UNITED STATES PATENT AND TRADEMARK OFFICE

10/799,044	03/12/2004	Maxime Arthur Maurice Samain	41170/171	6709
------------	------------	------------------------------	-----------	------

Office Action Summary	Application No. 10/799,044	Applicant(s) SAMAIN ET AL.	
	Examiner Noah C. Hawk	Art Unit 3636

DETAILED ACTION

Nakane et al. '803, Figure 2

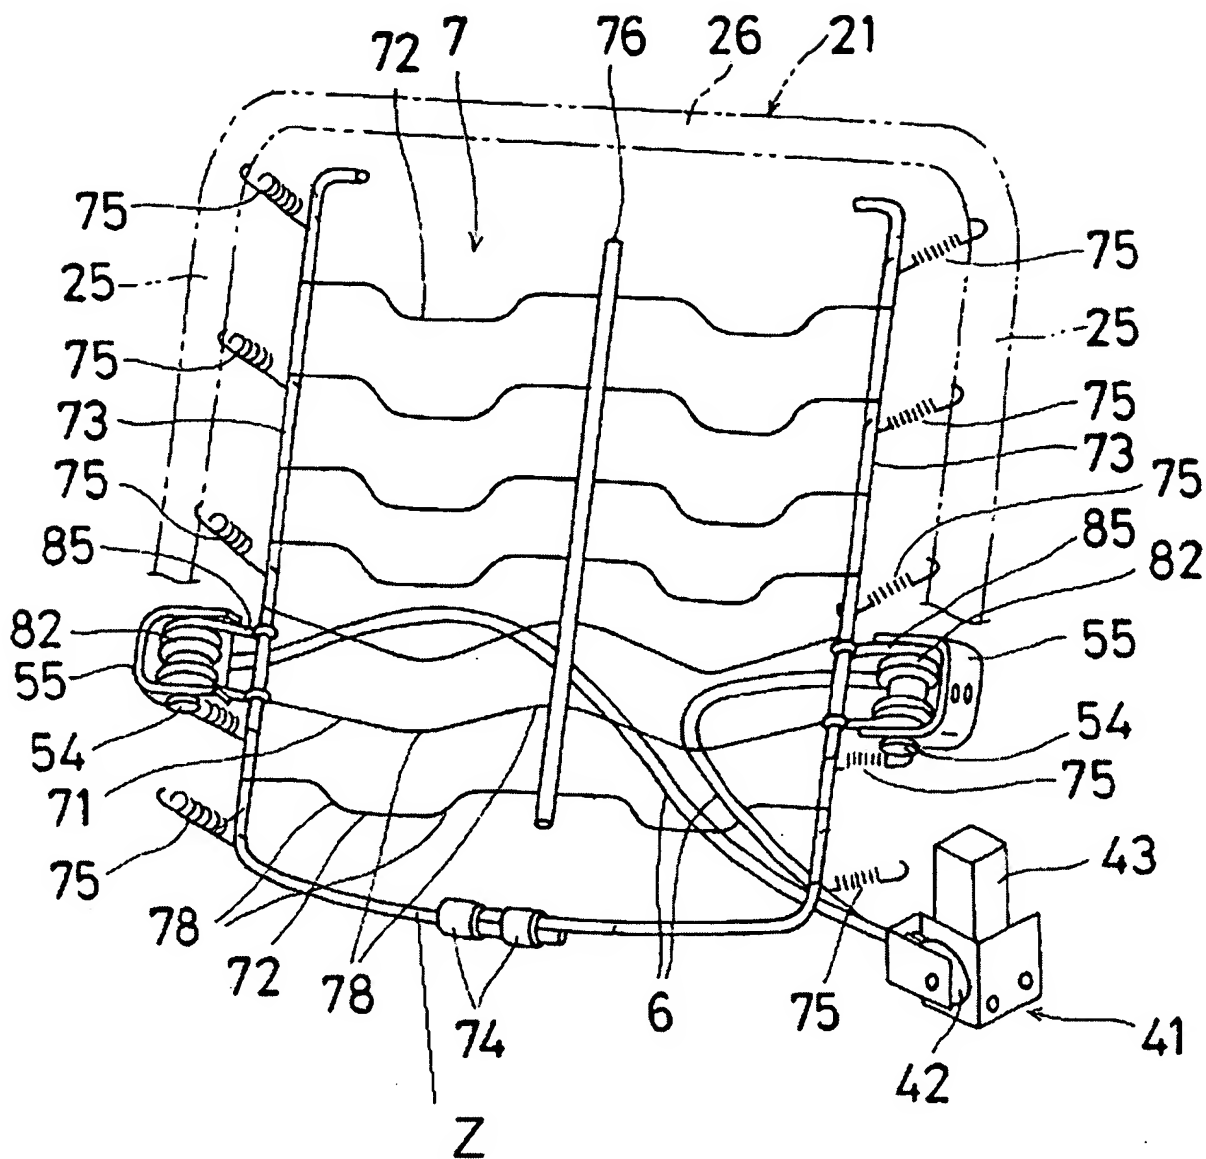
13. Claims 1, 10 and 11 are rejected under 35 U.S.C. 102(b) as being anticipated by Nakane et al. in US Patent 6499803. Nakane teaches a support structure having side rails (73), crossbars (Z) and a plurality of transverse wires (72) with an average bending stiffness less than that of the crossbars (the fact that the wires are thinner than the cross bars implies that they are less stiff than the cross bars.) Nakane further teaches a plurality of links (75) fixedly attached to the side rails and the seat frame (25).

McMillen et al. '501, Figure 2

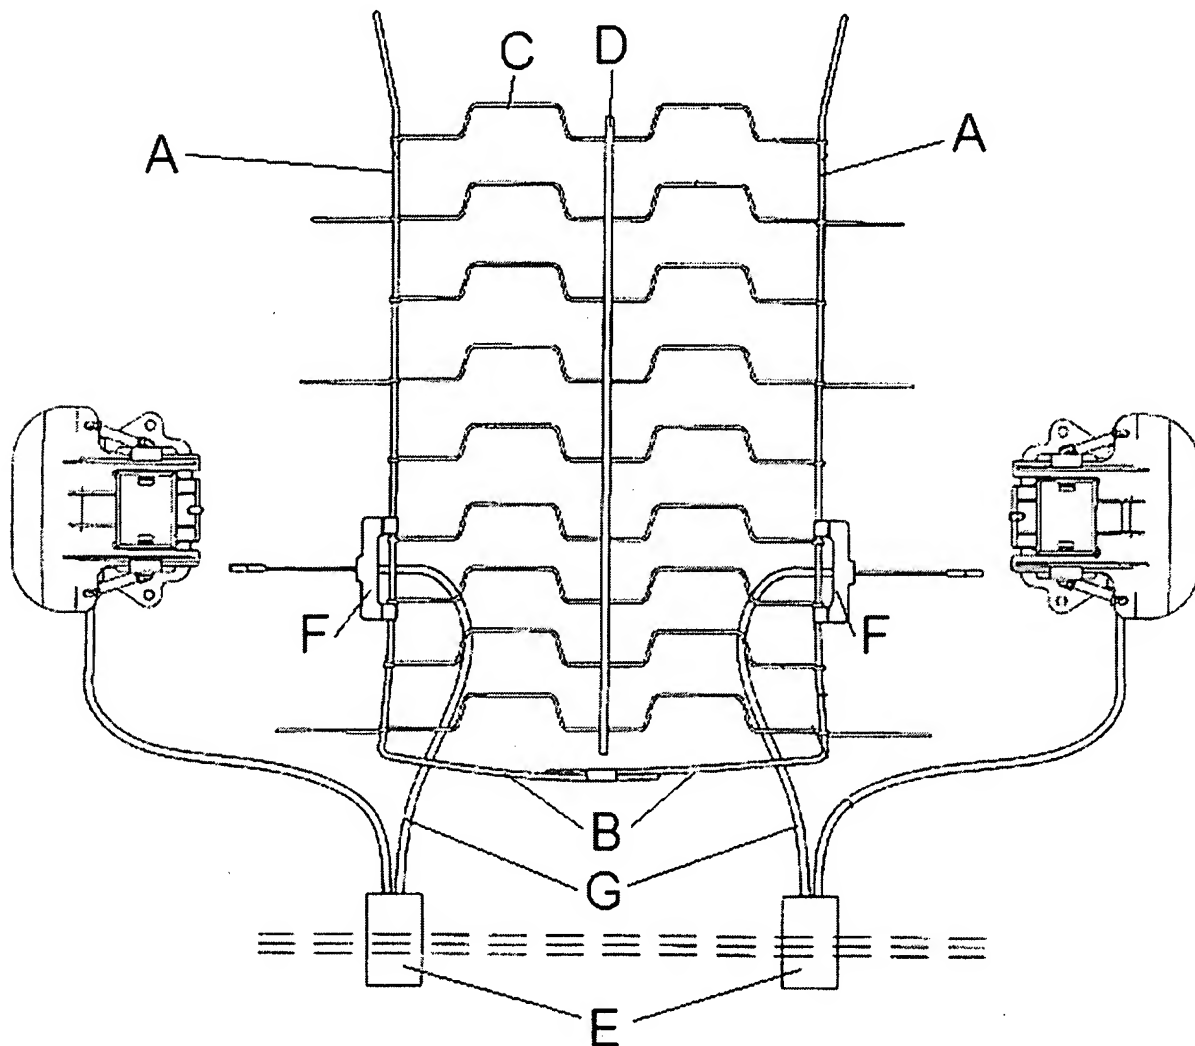
a. Regarding Claims 1 and 17, McMillen teaches a support structure comprising a pair of side rails (A, best seen in McMillen Figure 2, below), a pair

of cross bars (B, formed by portions of the side rails) and a plurality of transverse wires (C) with a bending stiffness less than that of the crossbars (the fact that the crossbars are thicker than the transverse wires implies that the crossbars are stiffer than the wires).

- b. Regarding Claim 2, McMillen further teaches that the crossbars are fixedly attached to the side rails with a clip (best seen in McMillen, Figure 2).
